Access Compliance Report

Public Rights-of-Way

Intersection ID: 16126	Main Street: E_W_T_HARRIS_BV	Cross Street: IDLEWILD_RD	Location: NW
ADA ID: E8BF5FA32616	Ramp Type: PerpDiag	Initial Pass/Fail: Fail	Overall Compliance: No
Severity Score: 21.25			
Codes/Mitigation Info/Possible Solution		Field Measurements/Component Compliance

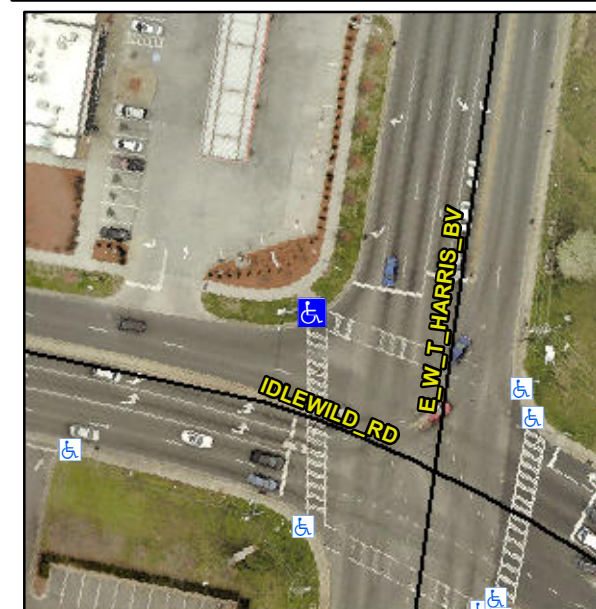
R304.5.1, R304.5.3

Compliance	Description	Data	Compliance	Description	Data
N/A	Ramp Length (in)	64.0	Yes	Ramp Slope (%)	6.0
No	Ramp Width (in)	47.0	No	Ramp XSlope (%)	5.2
N/A	Flare Type LT	N/A	N/A	Flare Type RT	N/A
N/A	Flare Slope LT (%)	N/A	N/A	Flare Slope RT (%)	N/A
N/A	Flare Traversable LT?	N/A	N/A	Flare Traversable RT?	N/A
N/A	Landing Length (in)	N/A	N/A	DWS Provided?	N/A
N/A	Landing Width (in)	N/A	N/A	DWS Contrast?	N/A
N/A	Landing Slope (%)	N/A	N/A	DWS Length (in)	N/A
N/A	Landing X Slope (%)	N/A	N/A	DWS Full Width?	N/A
N/A	Landing Curb? (Y/N)	N/A	N/A	DWS Offset (in)	N/A
N/A	Shared Landing?	N/A			
N/A	Gutter Ponding?	N/A	N/A	Gutter Slope (%)	N/A
N/A	Gutter Lip Ht (in)	1.0	N/A	Gutter X Slope (%)	N/A
N/A	Painted X Walk1?	Yes	N/A	Painted X Walk2?	Yes
	X Walk 1 Direction	To SW		X Walk 2 Direction	To SE
N/A	X Walk 1 Width (in)	111.0	N/A	X Walk 2 Width (in)	107.0
	X Walk 1 Slope (%)	0.4		X Walk 2 Slope (%)	2.6
	X Walk 1 X Slope (%)	4.0		X Walk 2 X Slope (%)	1.7

Remove & Replace Curb Ramp With Two New Directional Ramps or Equivalent.
